Preservation Department – Item 1, LPC-22-08731

**6301 12th Avenue, aka 6301-6323 12th Avenue, 1202-1216 63rd
Street, and 1201-1215 64th Street – Angel Guardian Home –
Individual Landmark
Borough of Brooklyn**

LPC-22-08731: 6301 12th Avenue, Angel Guardian Home - Individual Landmark

PUBLIC MEETING SCOPE 09/20/2022

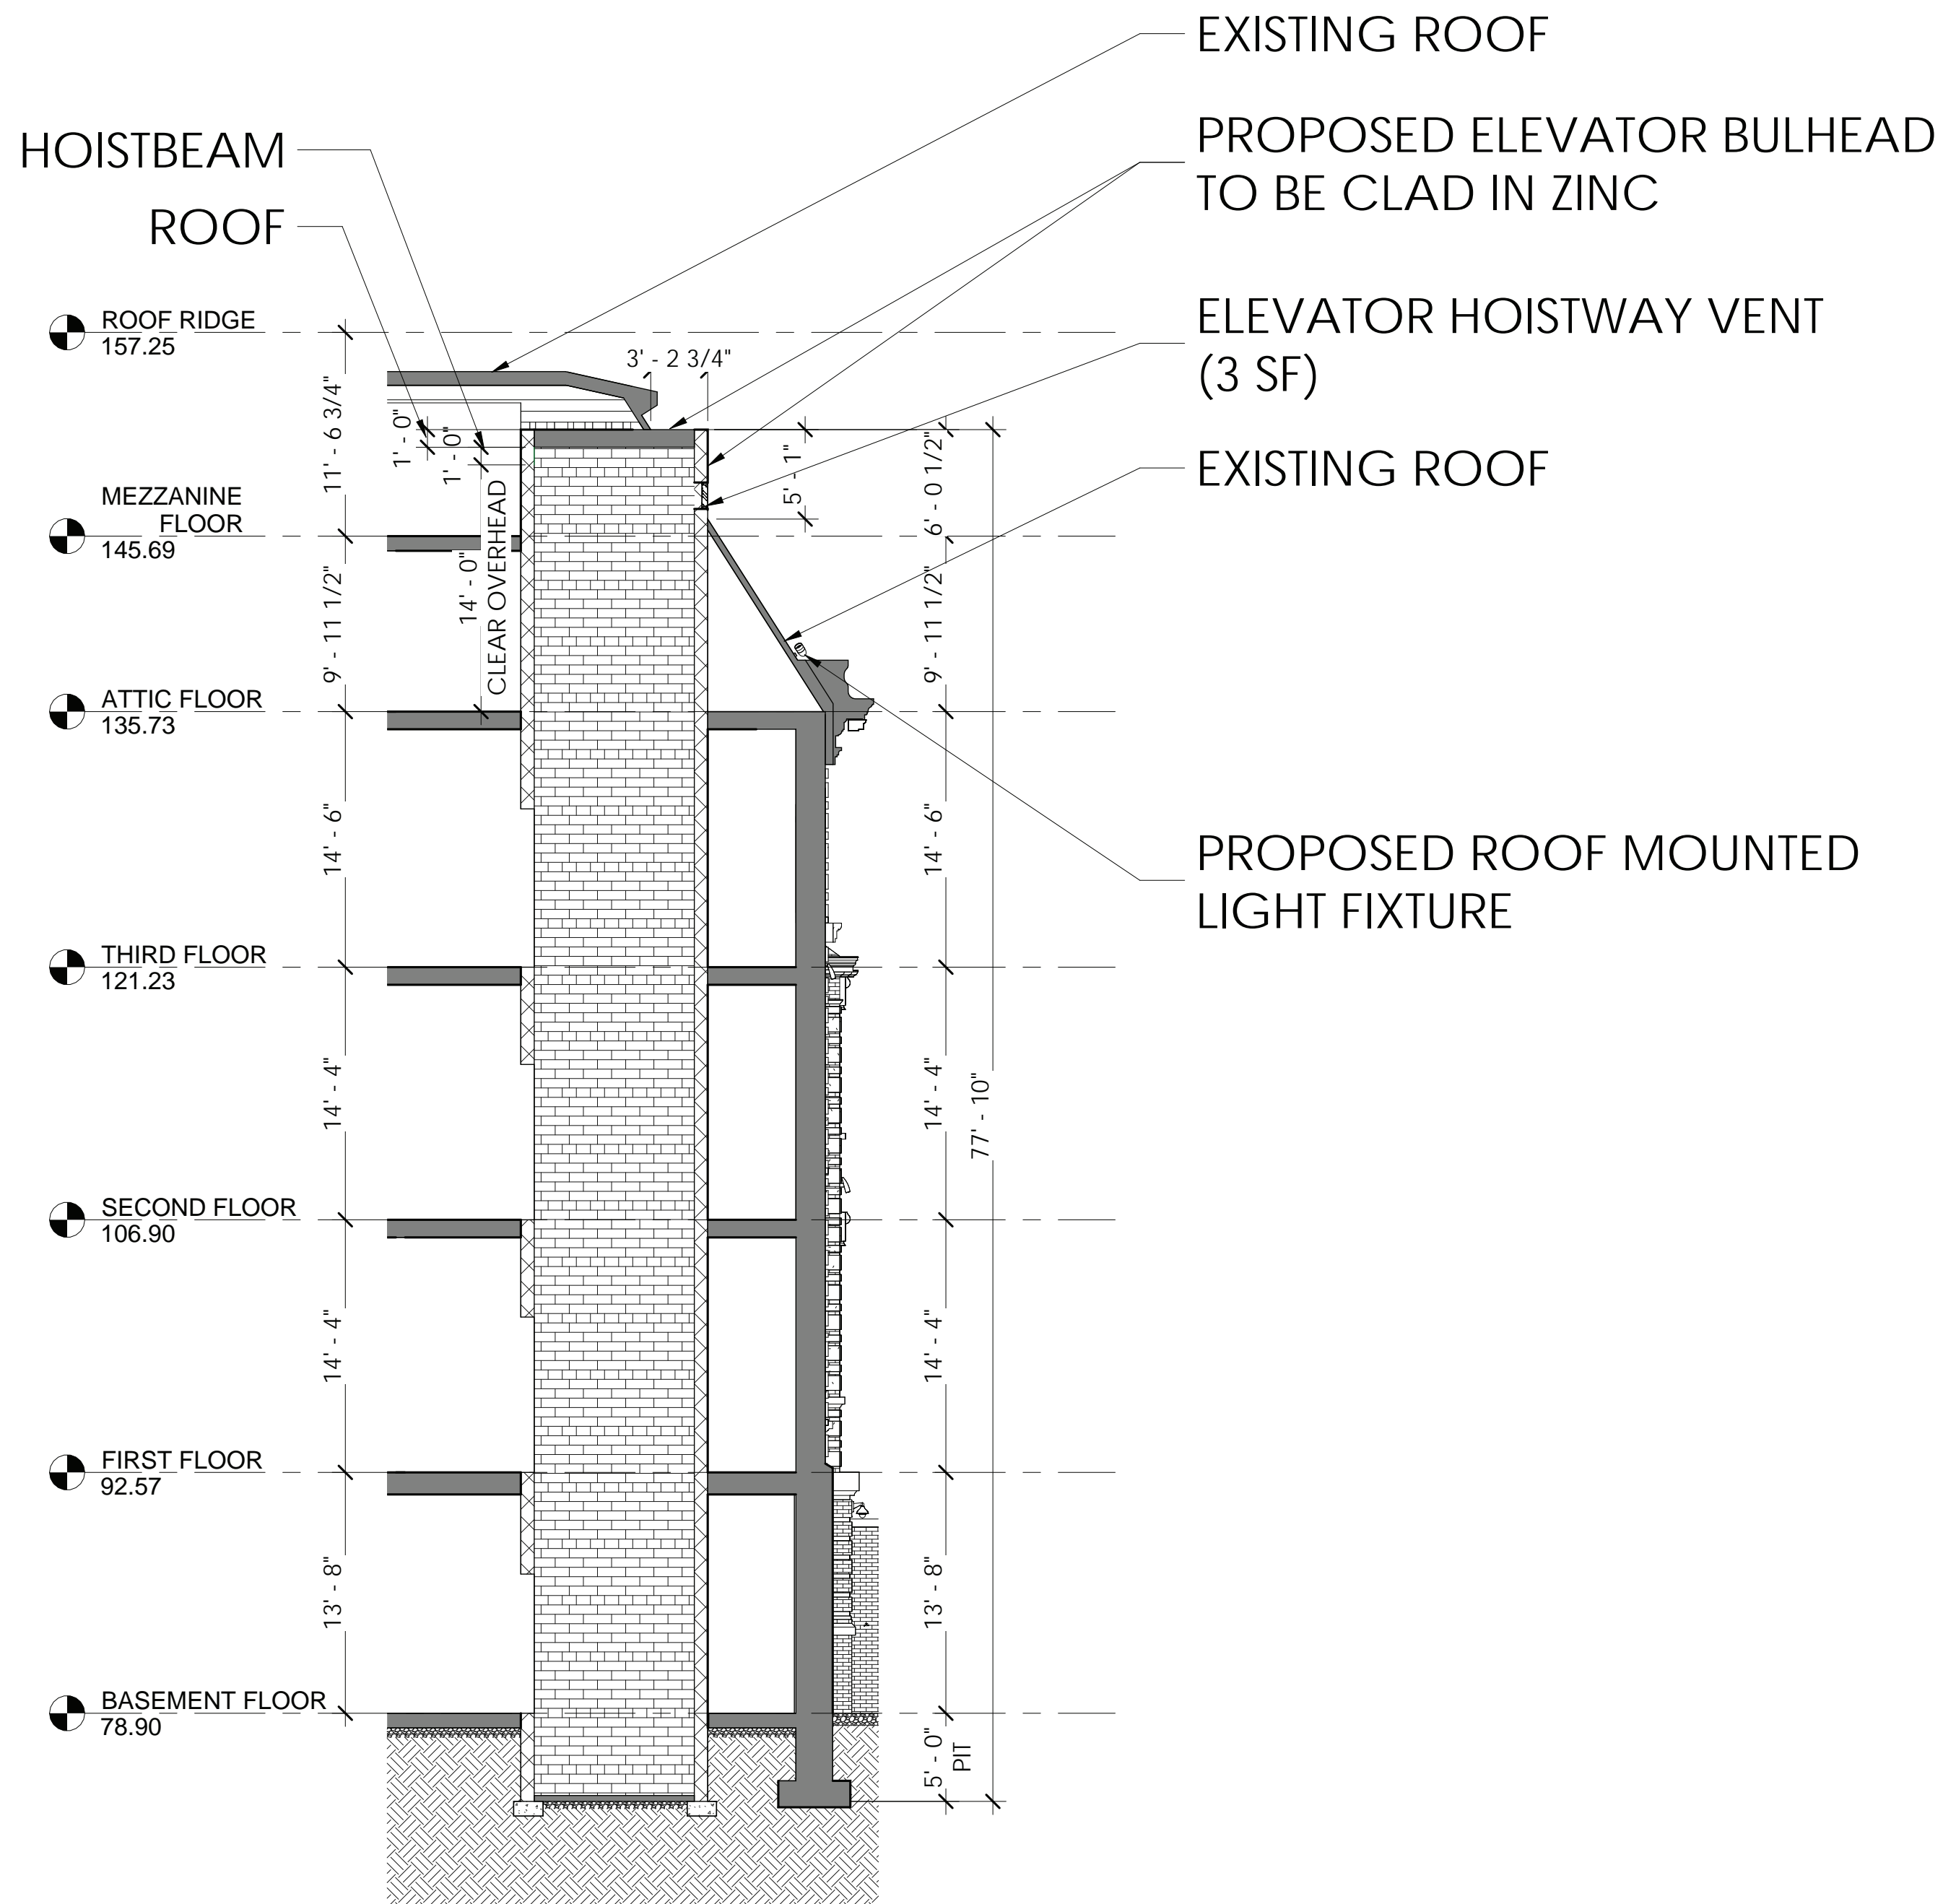
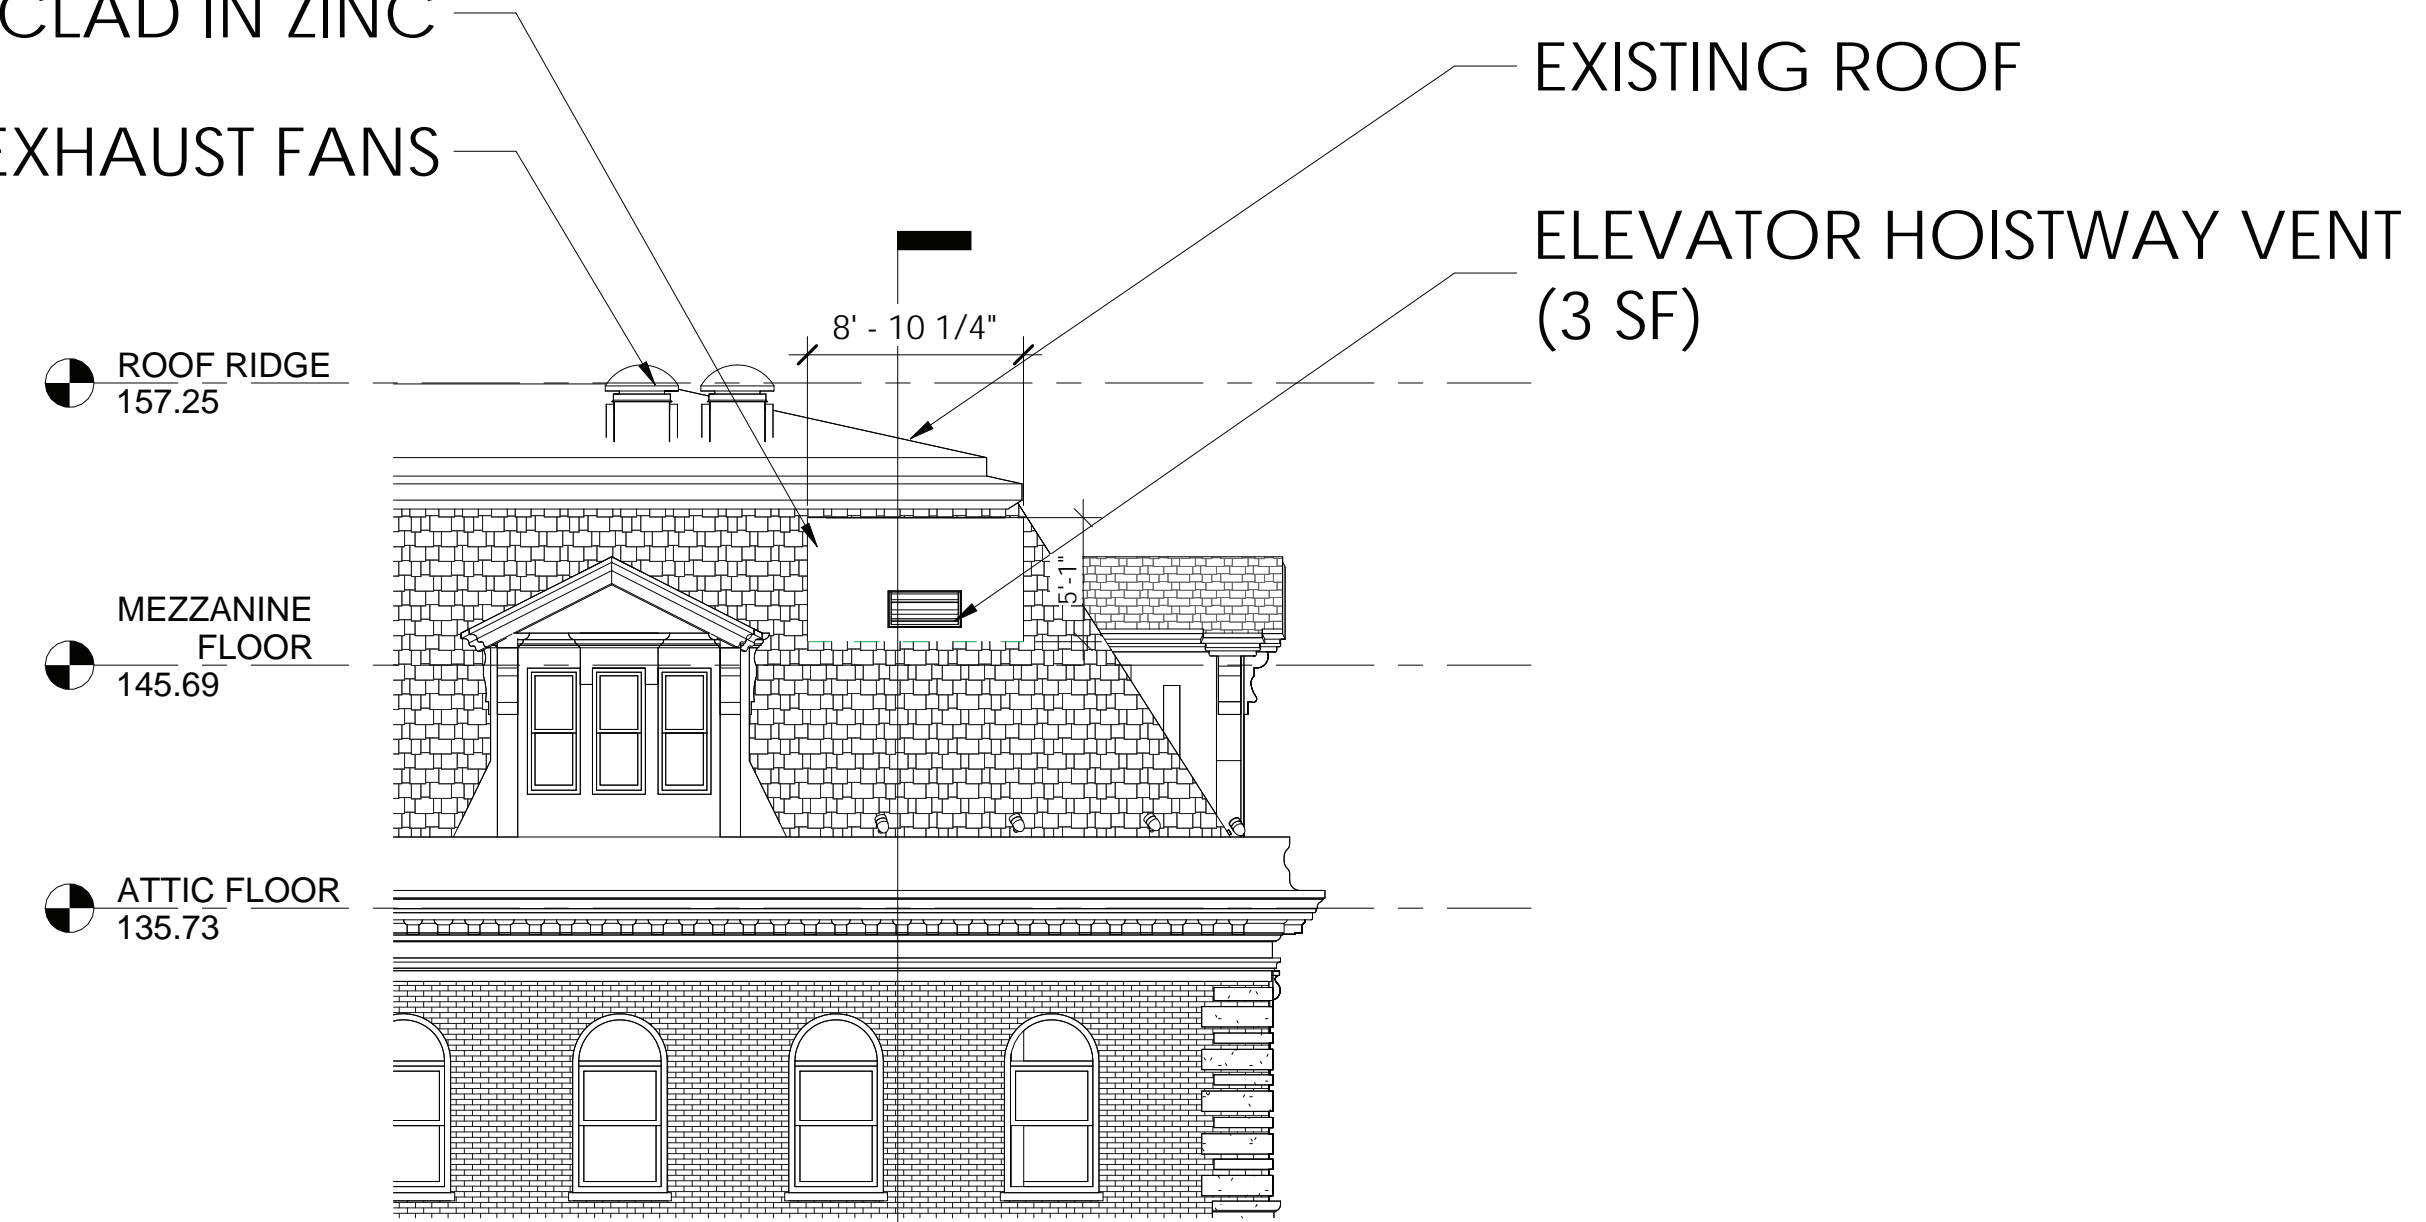
- CHANGES:
- ELEVATOR BULKHEAD HEIGHT
 - NEW ELEVATOR HOISTWAY VENT

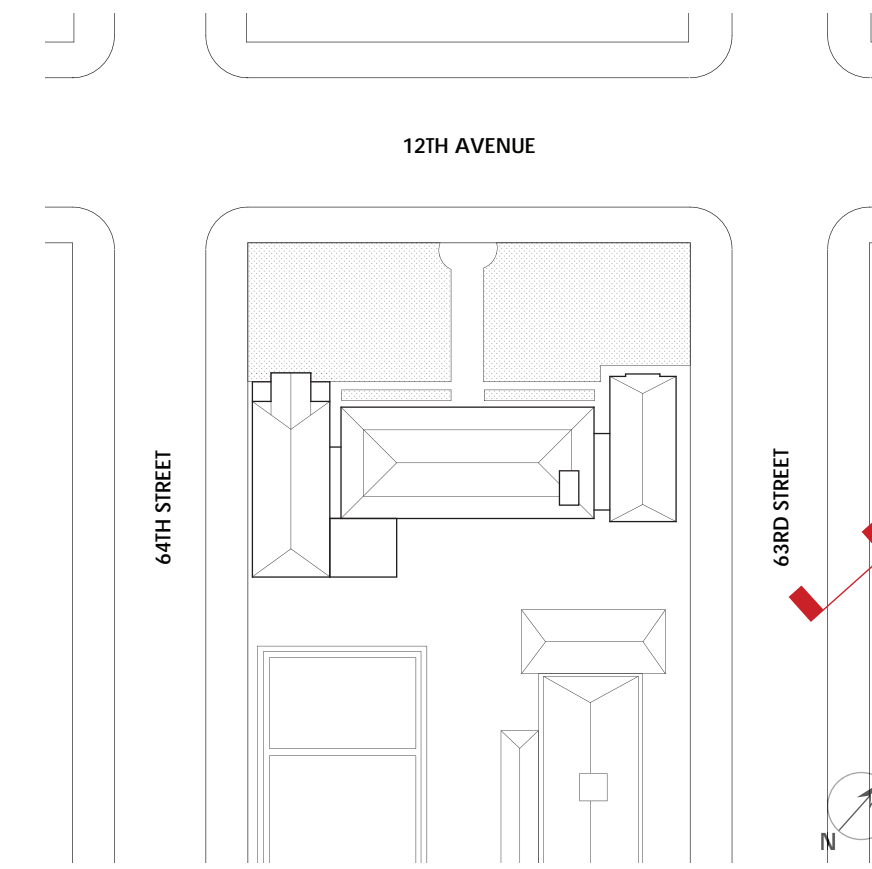
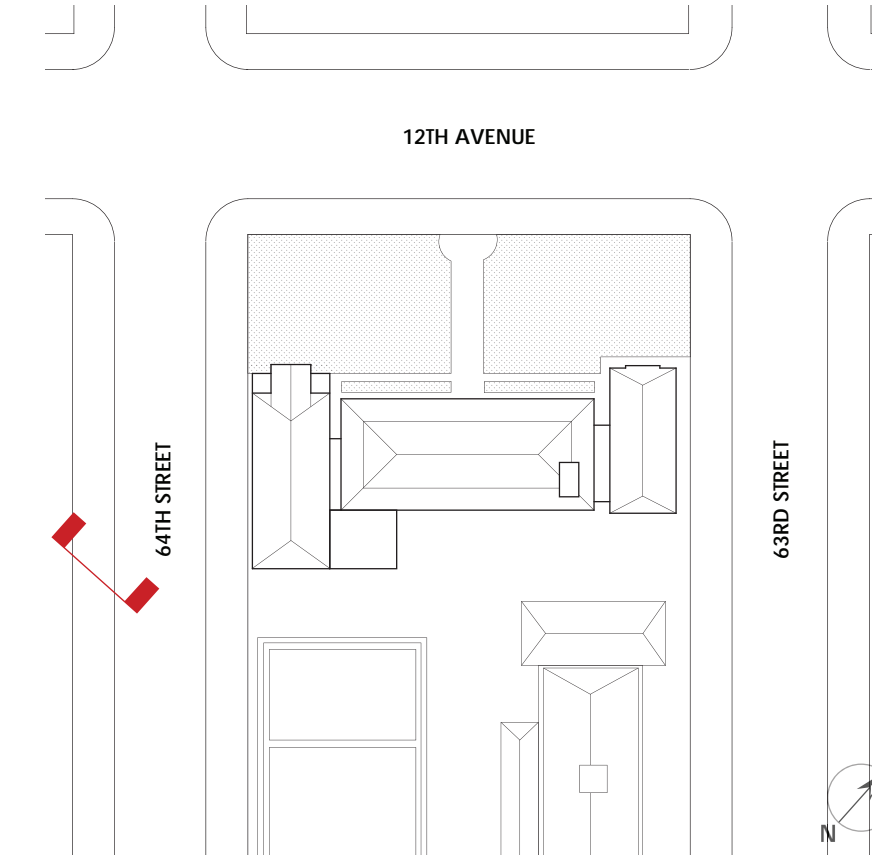
- CHANGES:
- ELEVATOR BULKHEAD HEIGHT
 - ELEVATOR HOISTWAY VENT
